الموضوع: إشعار بمتابعة جهاز طبي
Hoists, overhead/wall track system,

Urgent field safety notice

Regarding RoomTransferHook 70200010

Fig. 2 Correct attachment of RTH to H-adapters.

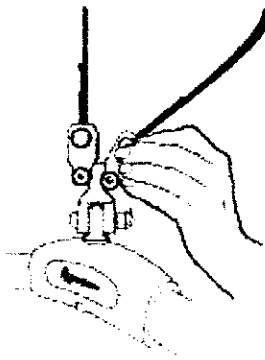
When manoeuvring a patient from one ceiling lift unit to another using an RTH, a critical point is the actual transfer of the RTH between the H-adapters at the end of the lift straps (Fig. 2). If the RTH is not correctly attached to the H-adapter, the RTH could slide out of the adapter, causing the patient to fall to the floor.
